NEW BEDFORD WATER WORKS

**From:** Stephanie Crampton  
**Sent:** Friday, August 19, 2022 8:40 AM  
**To:** Dan Galante  
**Cc:** Amanda Jupin; Erin M. Iacoponi  
**Subject:** RE: [EXTERNAL] Hetland Skating Rink Utilities

Attached is a revised utility plan for the project (C-04 by AECOM). It shows the following for the utilities:

C-04

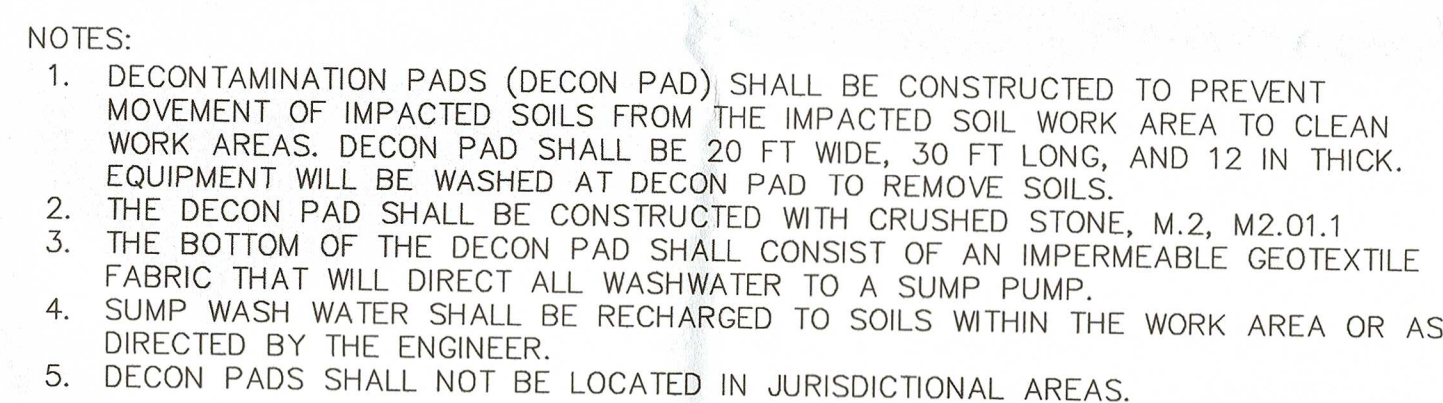
I have reviewed the revised site plan for the project with the changes made to the utilities. Two comments I have (which do not require an alteration on the plan) is that if the sewer service's manhole is not located, a clean out should be installed (in accordance with City spec – 2' off of property line into City layout). Also, the northerly oil separator is proposed to be encroaching on the City layout line for that area. Be sure the unit is installed 100% within private property.

Plans are all set so you are good to come file for your permits. You will need one full size copy of whatever sheets are relevant to each permit that you are applying for. For example: Water permit would require the utility sheet you send me C-04 as well as sheet C-06 as noted on the call out for the water service. Stormwater permit will require sheet C-04 and C-08. Etc, etc

1. Sewer is just remove / replace to property line
2. Water is now putting in a 2" service from the main (subject to the conditions you had previously indicated)
3. Stormwater now has 2 treatment units added to the system before the 2 existing discharges out into the drain in the street (we did verify they both exist – even though only one was shown on your plan).
